**NEW MEXICO  
ENVIRONMENT DEPARTMENT**

*Hazardous Waste Bureau*

**RE: REPLACEMENT PAGES, QUARTERLY PRE-REMEDY MONITORING AND  
SITE INVESTIGATION REPORT FOR JANUARY-MARCH 2011, BULK  
FUELS FACILITY SPILL, SOLID WASTE MANAGEMENT UNITS ST-106 AND  
SS-111, MAY 2011  
KIRTLAND AIR FORCE BASE, EPA ID# NM9570024423  
HWB-KAFB-11-008**

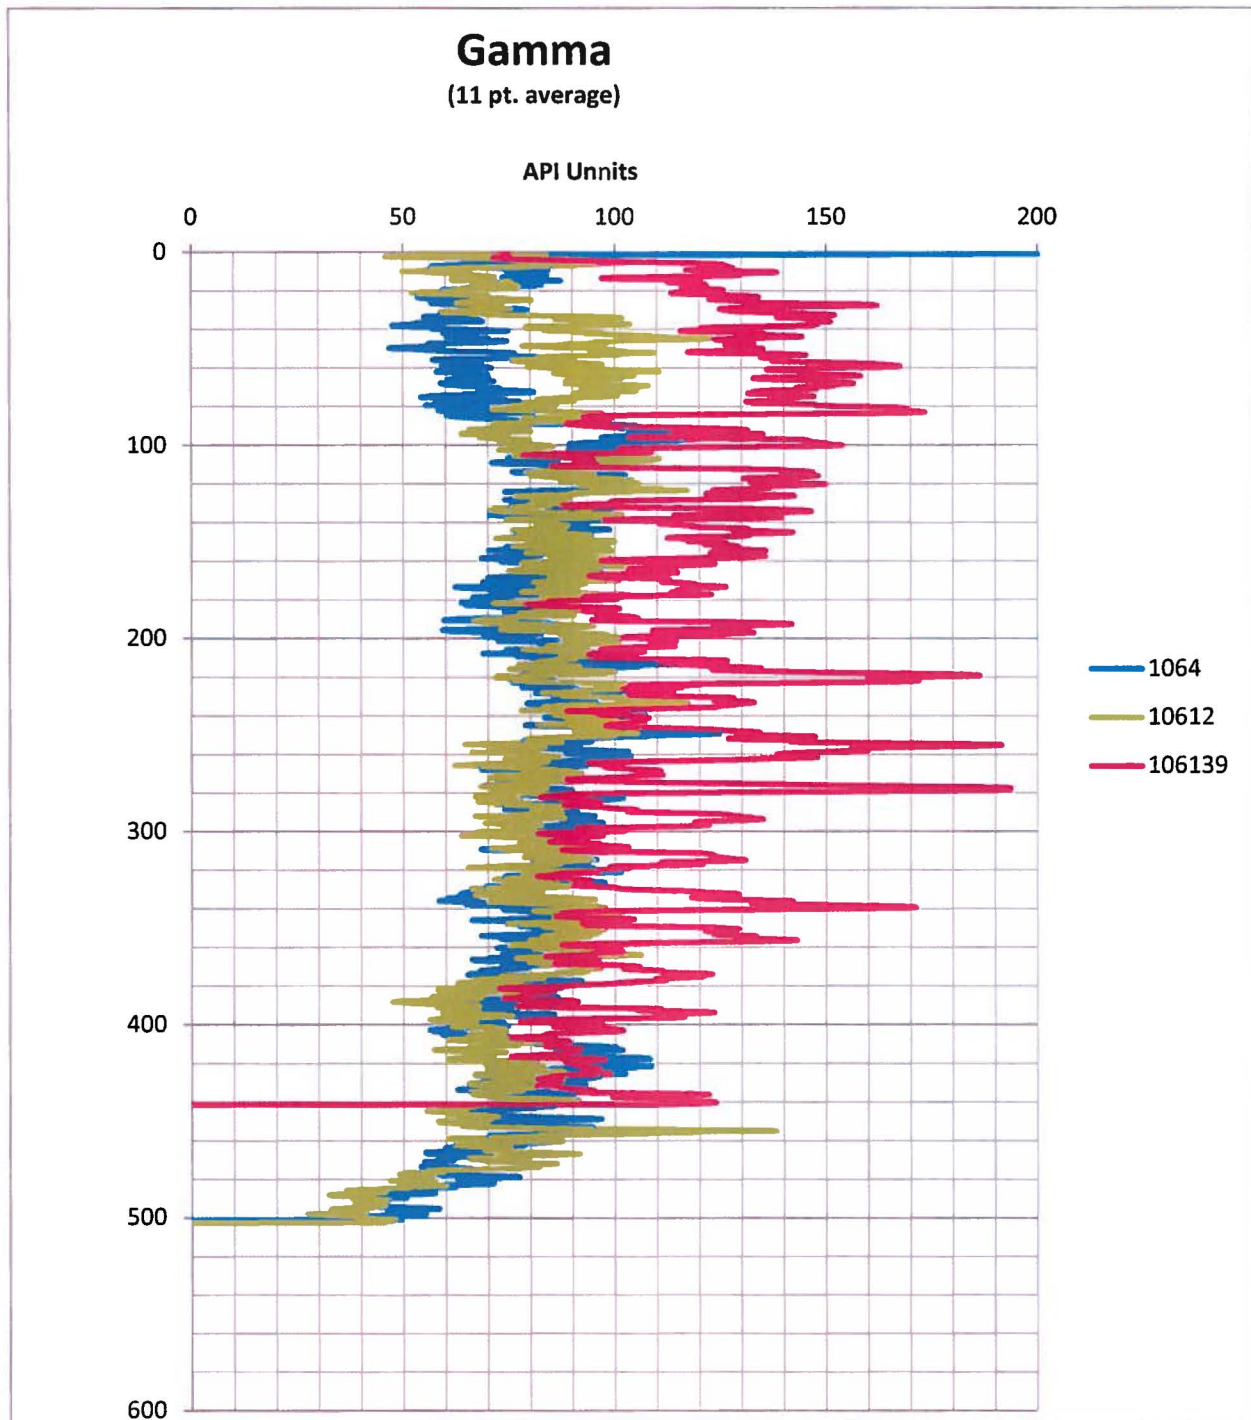
1. Figure 8 of this letter shows the gamma logs from two groundwater monitoring wells (KAFB-1064 and KAFB-10612) situated about 300 feet apart, with a soil-vapor monitoring well (KAFB-106139) located between them. There is a significant difference between the logs generated for the groundwater monitoring wells and that for the soil-vapor monitoring well. The soil-vapor well exhibits many gamma peaks and an overall higher background count than the nearby groundwater monitoring wells. Given the proximity of the three wells, these differences may be related to well construction and not to lithologic differences. However, the gamma peaks do not necessarily correspond to the well construction details. Similarly, the neutron logs also exhibit different characteristics between the groundwater monitoring wells and the soil-vapor well. Provide an explanation, if possible, as to why the logs differ.

**Figure 9.** Induction and neutron logs from KAFB-10618. Note unusual characteristics of the short normal induction log (labeled ShtRes\_F).

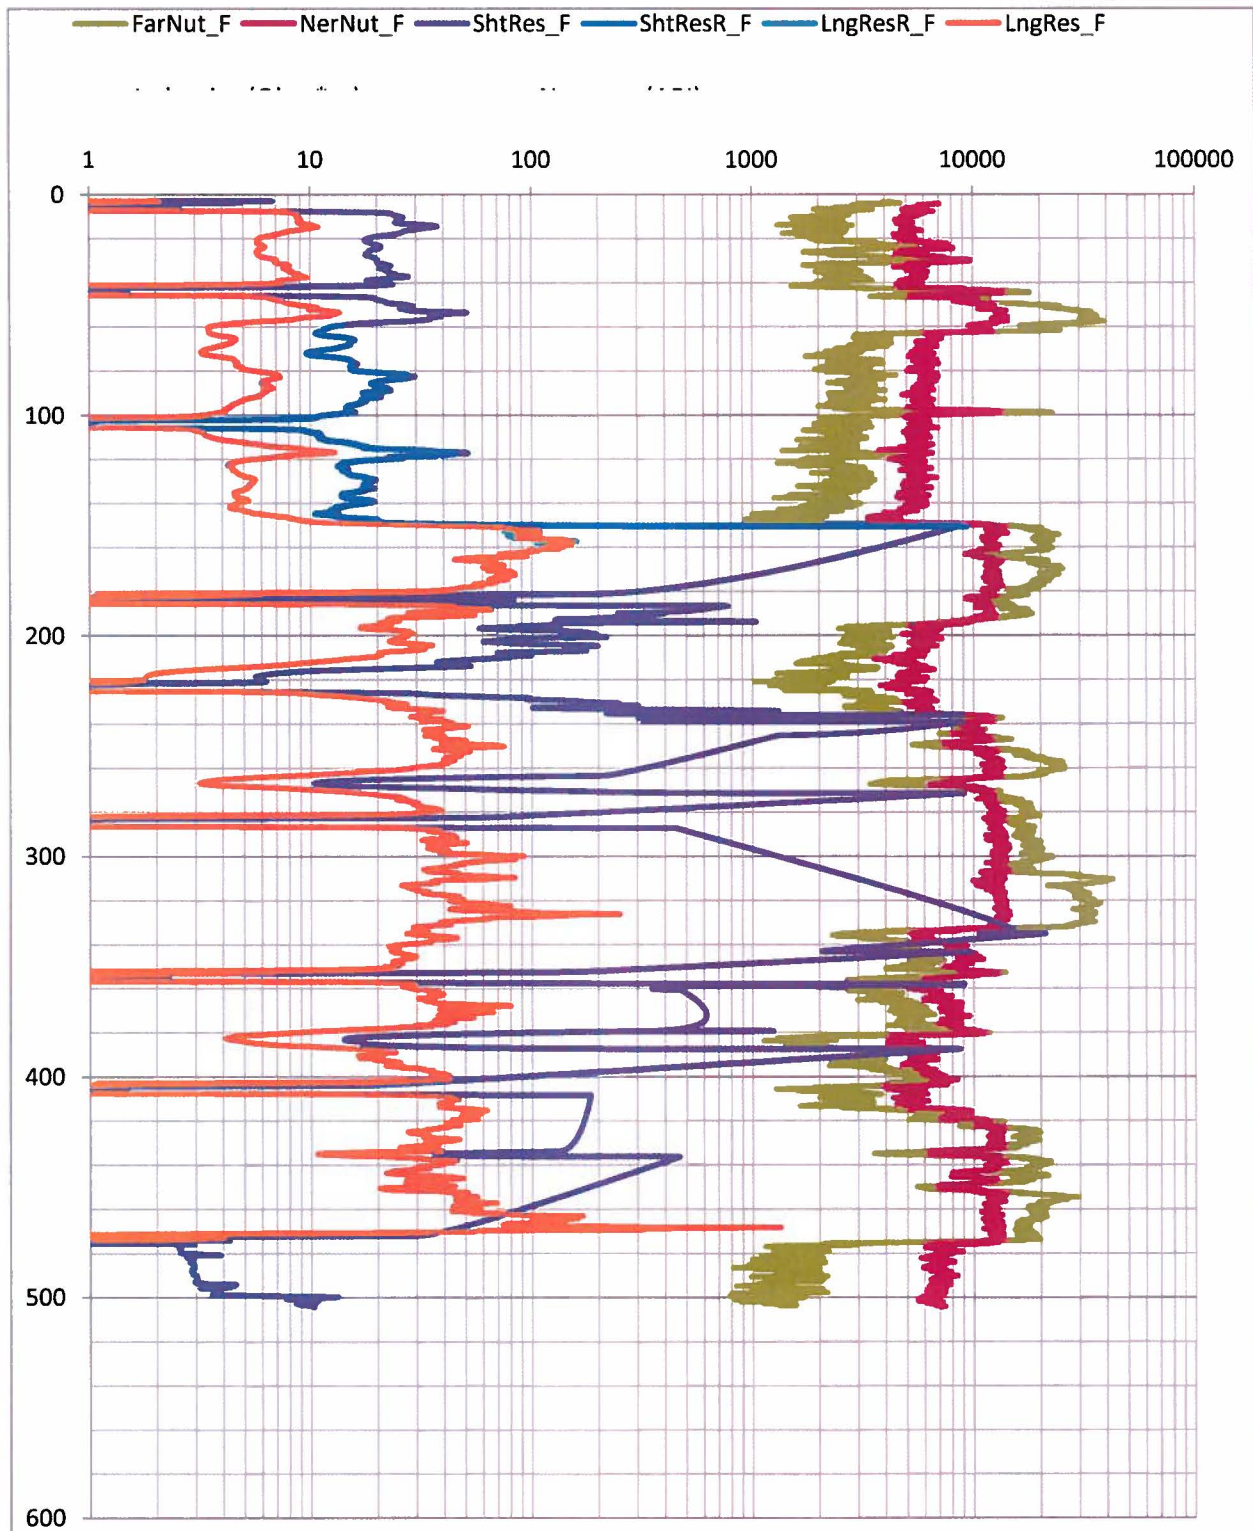
2. In addition, NMED notes that the short normal induction log for KAFB-10618 (see Figure 9 of this letter) is unusual in shape, suggesting a failure of the instrument or other error. While the Permittee's contractor verbally mentioned there was a problem inherent with that specific well at the July 12 meeting, the Permittee must provide a discussion of what the Permittee has done to identify the problem, correct the problem, and acquire reliable information from that well.
